**NORTHFIELD TOWNSHIP PLANNING COMMISSION  
NOTICE OF REGULAR MEETING  
January 17, 2018 at 7:00 p.m.  
Second Floor, Public Safety Building  
8350 Main Street, Whitmore Lake, MI 48189**

Re: Jomar Park Phase 2 – Private Road  
Private Road Review #1  
*Midwestern File No.: 16287*

JOMAR PARK PHASE 2 - PRIVATE ROAD  
NORTHFIELD TOWNSHIP, WASHTENAW COUNTY, MICHIGAN  
PRIVATE ROAD DESIGN  
GRADING & SOIL EROSION CONTROL PLAN

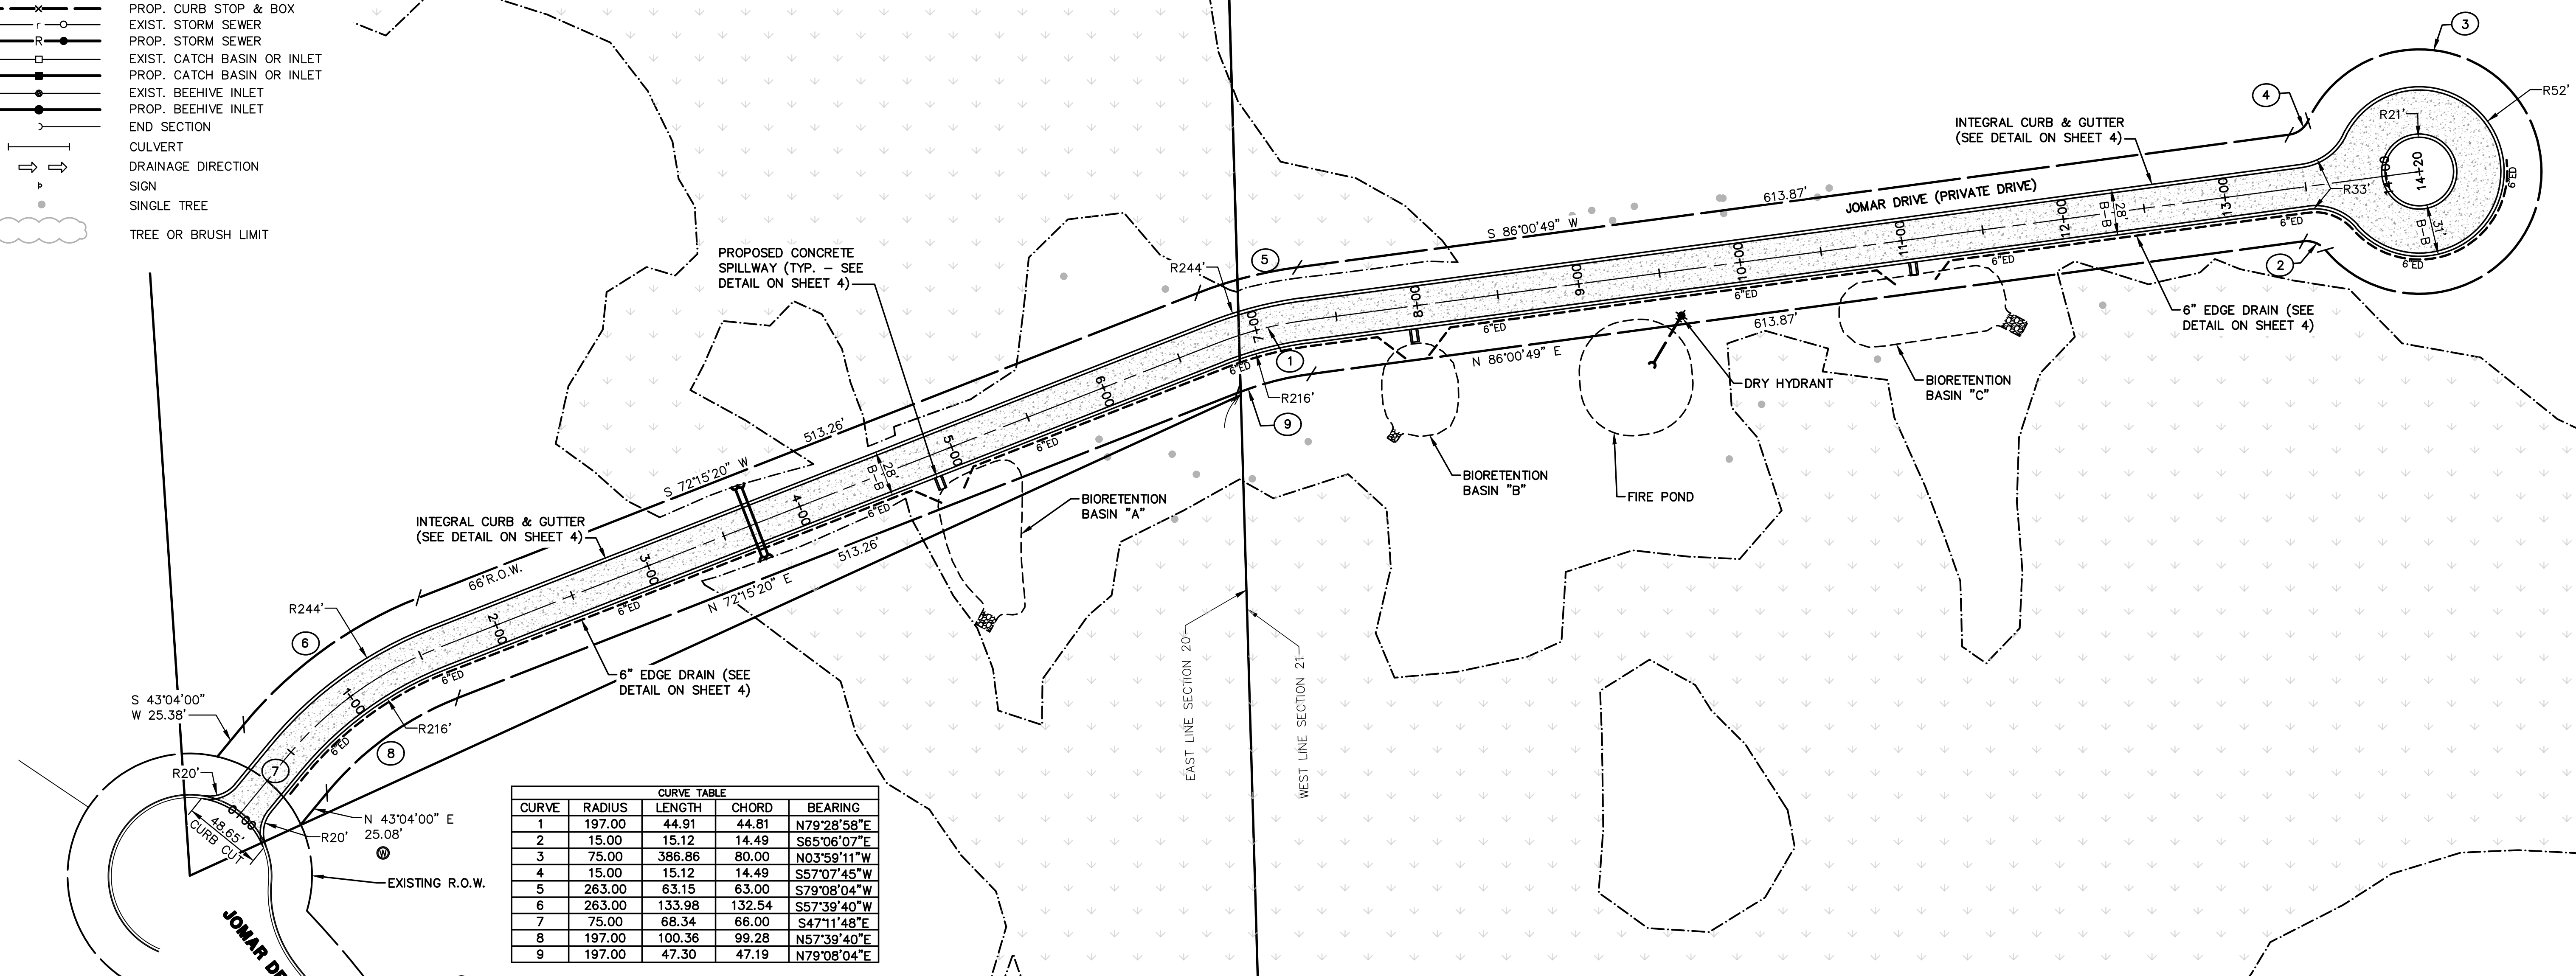
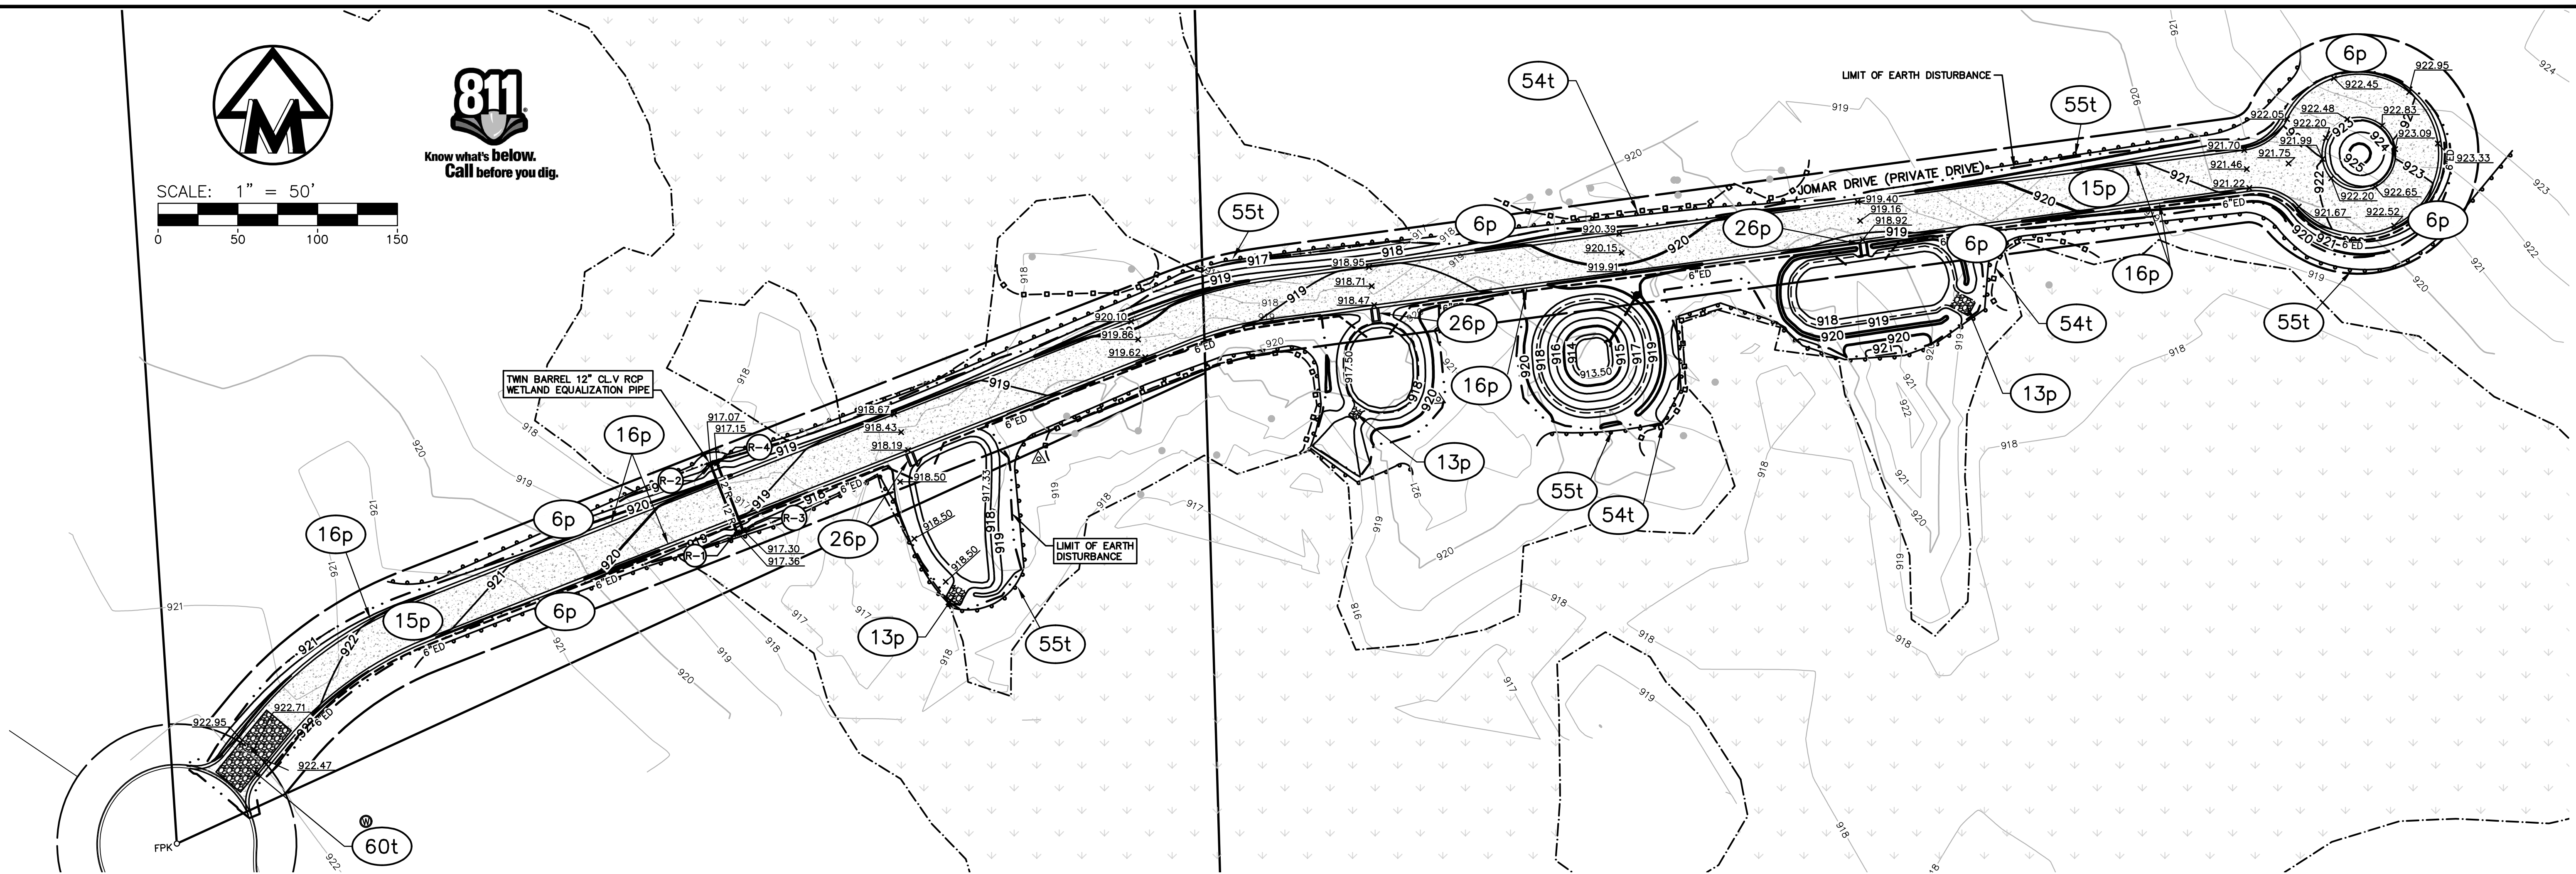
2. A proposed drainage area map shall be provided.

3. A full profile of the proposed storm sewer system shall be included on the plans.

*A proposed drainage area map has been provided on Sheet 5.*

*A profile of the wetland equalization pipes has been included on Sheet 5.*
